May 11, 2021

**Re: Panoche Energy Center, LLC follow up December 18, 2020 meeting with EPA on
UIC Permit No. R9UIC-CA1-FY17-2R**

Through this letter, Panoche Energy Center, LLC (PEC) provides its comments on the draft Underground Injection Control permit R9UIC-CA1-FY17-2R (Draft Permit) under docket number [EPA-R09-OW-2021-0147](#) to the U.S. Environmental Protection Agency (EPA), Region 9. The Draft Permit would authorize PEC to continue operating four (4) Existing Wells, known as IW1, IW2, IW3 and IW4, and construct and operate two Potential Wells, IW5 and IW6 once all permit conditions pertaining to the wells have been met for PEC's power generation facility (the "Facility"). In addition, the Draft Permit would require PEC to install a monitoring well to assess subsurface conditions associated with identified underground sources of drinking water (USDW).

Figure 1

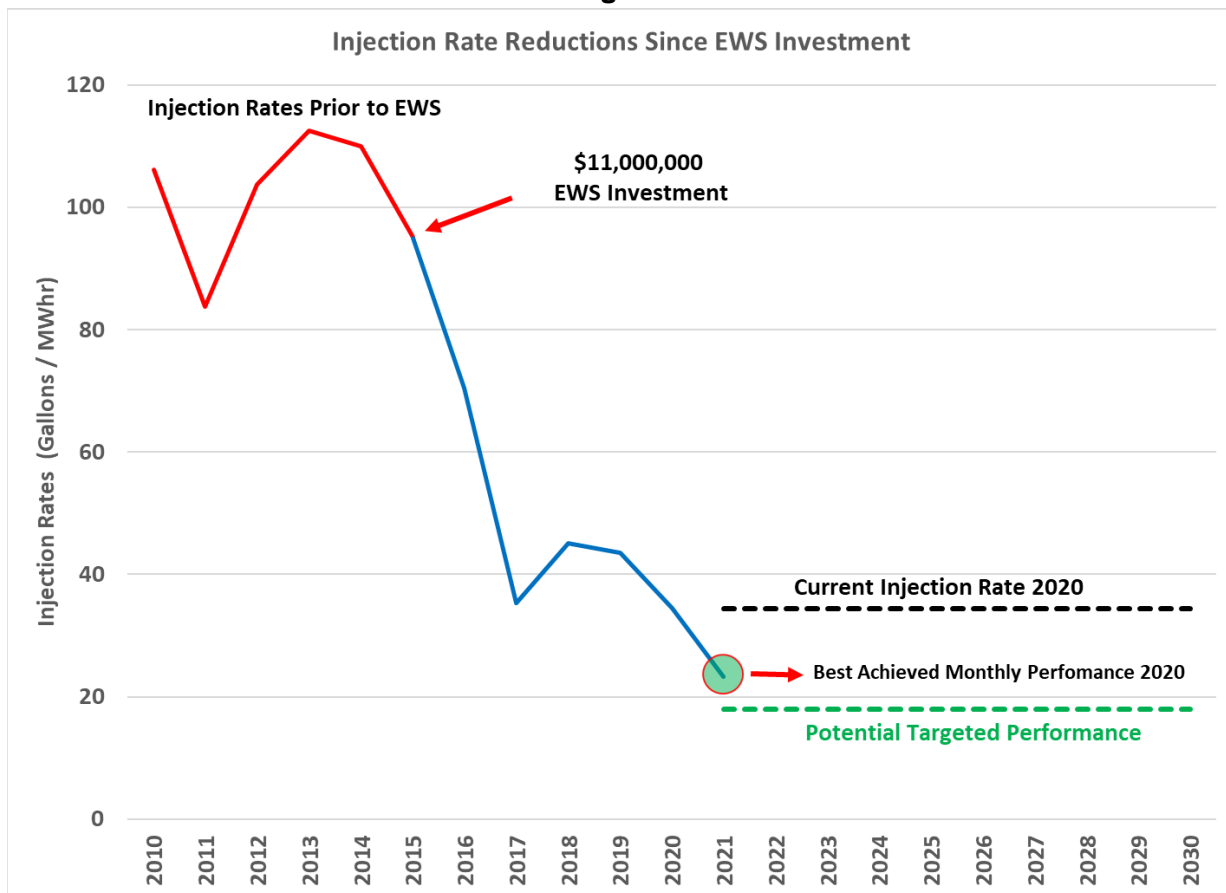
Prior to the EWS being commissioned, injection rates on a gallon per megawatt hour (“gal/MW hr”) were as high as 112 gal/MW hr. Since the EWS was commissioned, injection rates have decreased significantly. Year-to-date in 2020, injection rates have reduced by approximately 70% to 34 gal/MW hr. Through continued optimization the Facility has been able to achieve injection rates as low as 22 gal/MW hr. See Figure 1 below.

Figure 2

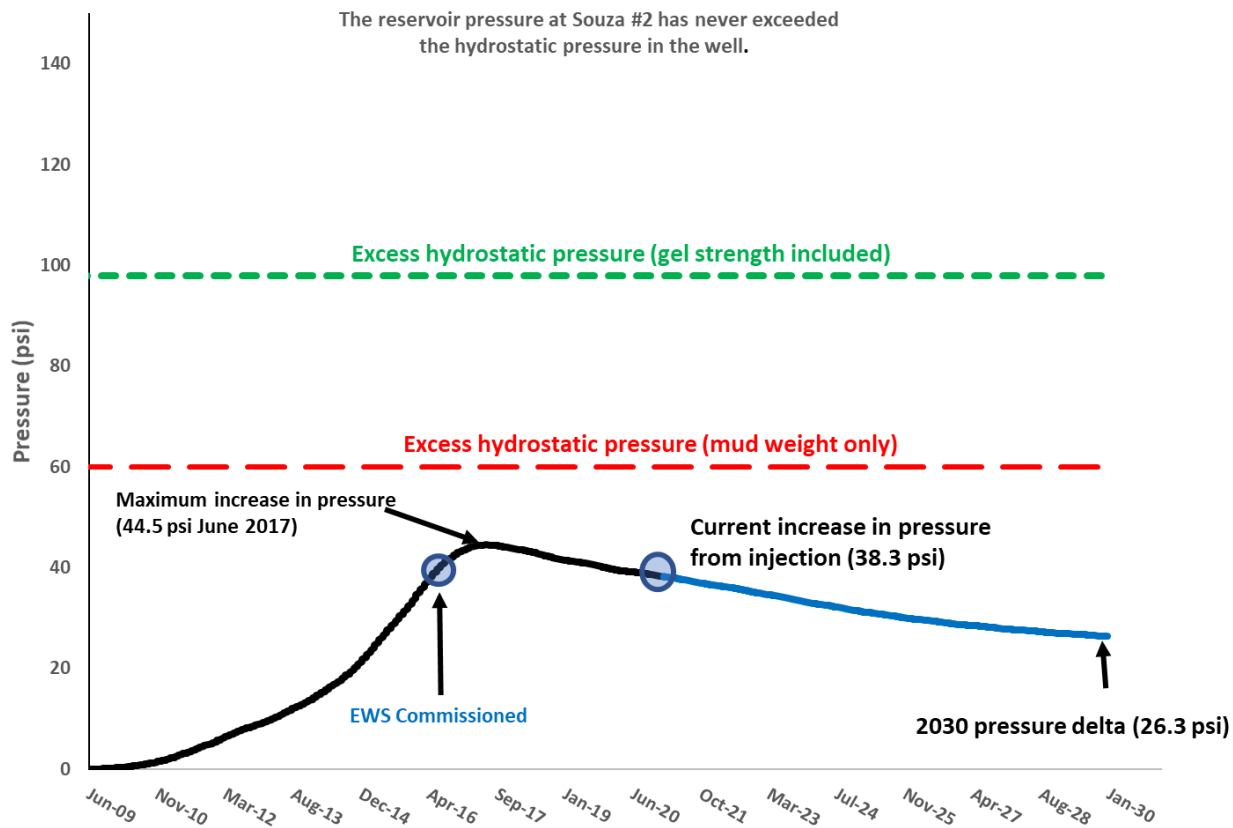
PEC's September 2020 Analysis for the EWS and reduced injection volumes (Figure 2) shows that the mud column hydrostatic pressures in Souza #2, Silver Creek #18 and England #1-31 (Figures 3, 4, and 5, respectively) have always been in excess of the maximum reservoir entry pressures. In addition, the EWS evaluation also shows that each well experienced its highest increase in reservoir pressure in 2017; and since then, induced pressure within the reservoir has and will continue to decrease, due to lower injection volumes, throughout the life of the permit. These improvements are a direct result of the EWS commissioning in 2016.

Souza #2 Pressure History and Expected Future Pressure Decreases

The reservoir pressure at Souza #2 has never exceeded the hydrostatic pressure in the well.

Figure 3

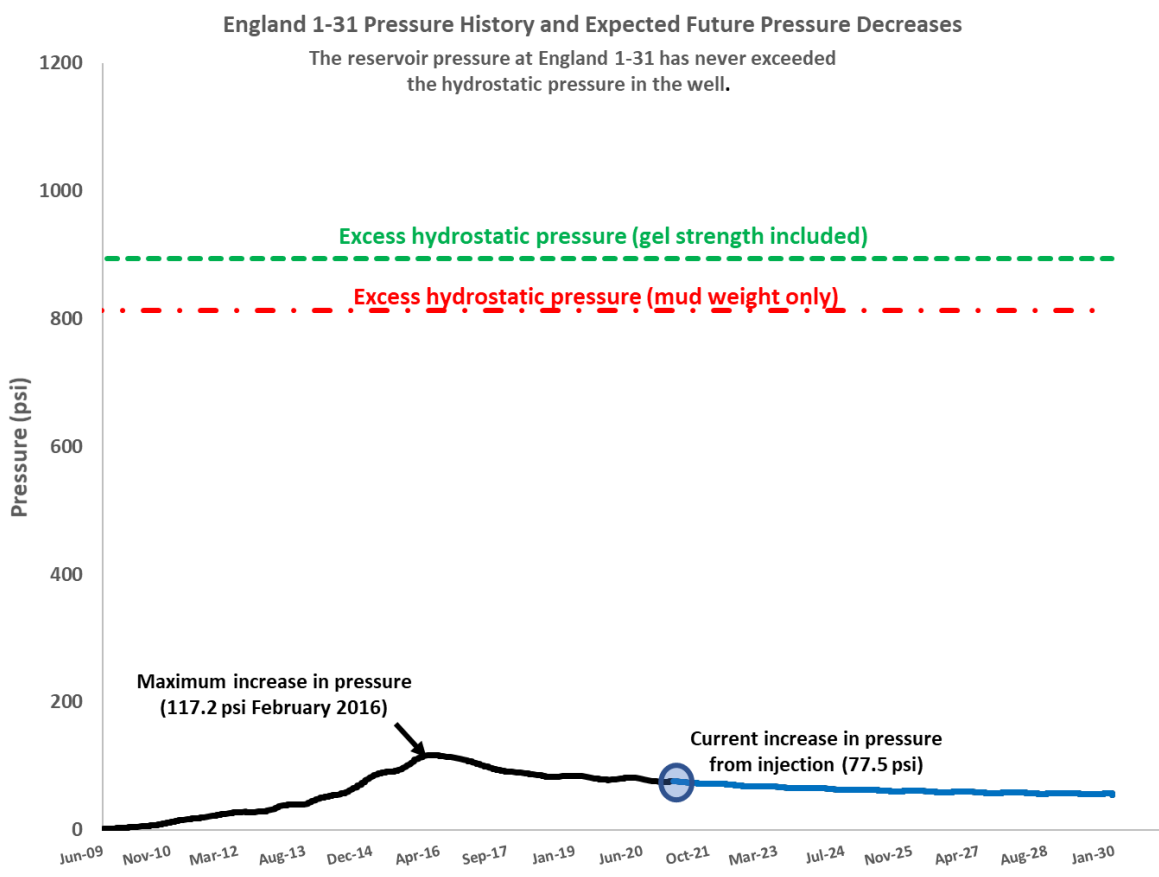
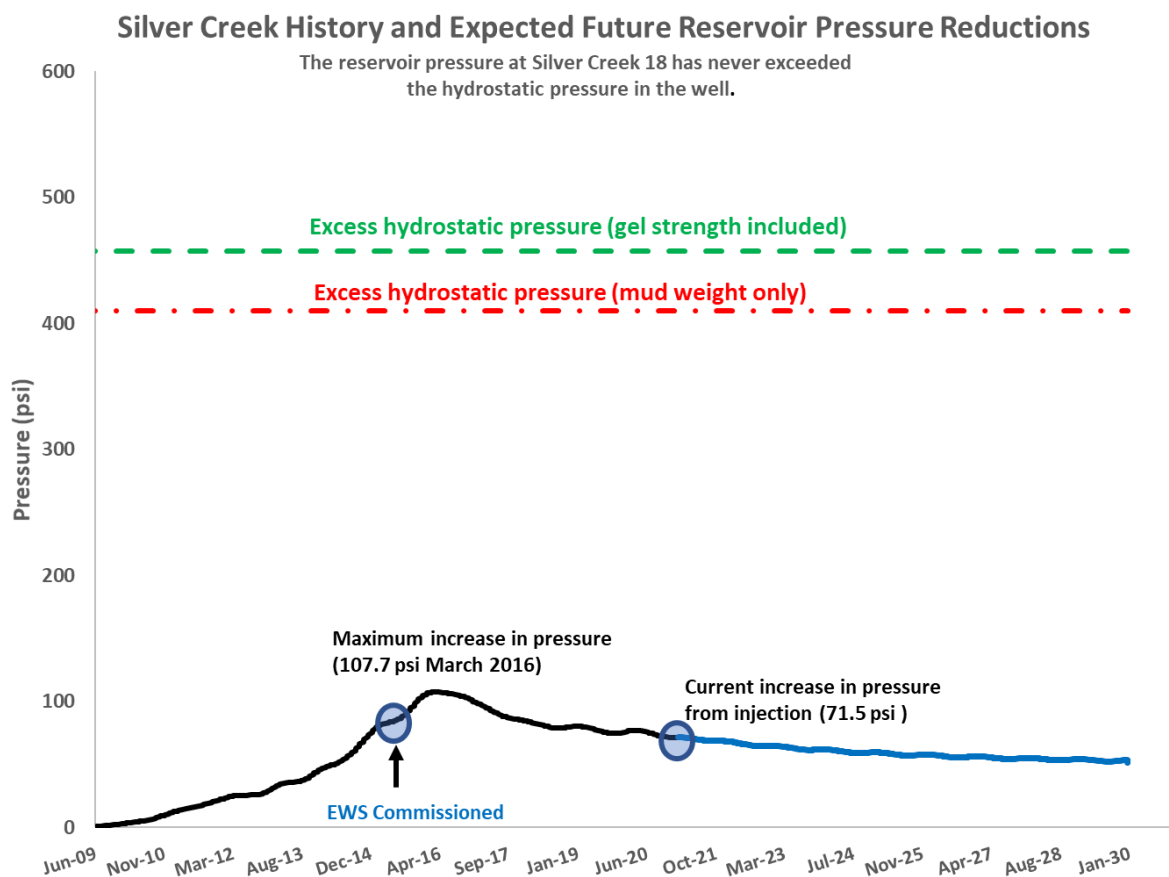
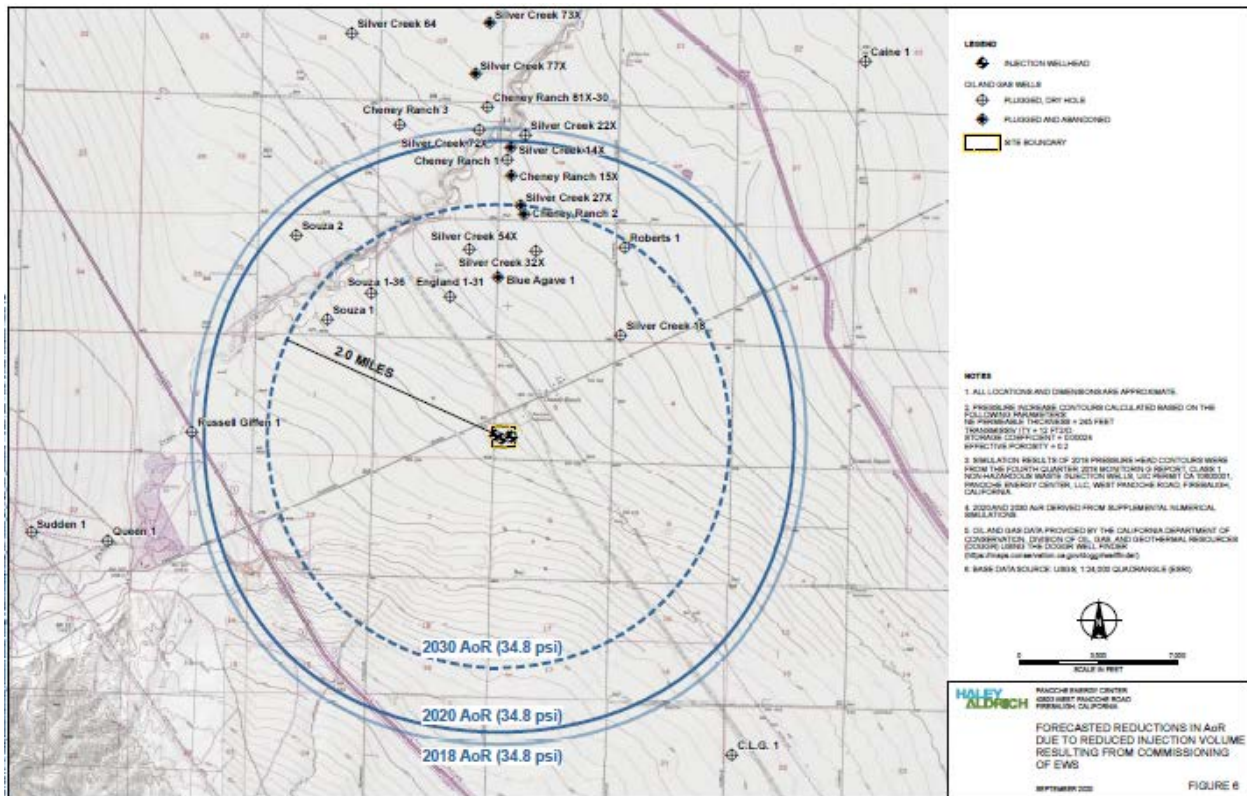
Based on the September 2020 Analysis, the current reservoir pressure differential (above initial pressure) at Souza #2 is 38.3 psi (see Figure 2 below). This pressure differential will continue to decrease through the permit term. Figure 2 shows the effect of the EWS on the differential hydrostatic pressures exerted at Souza # 2; Figure 3 shows the effect of the EWS on the differential hydrostatic pressures exerted on at the England # 1-31 well; and Figure 4 shows the effect of the EWS on the differential hydrostatic pressures exerted at Silver Creek #18.
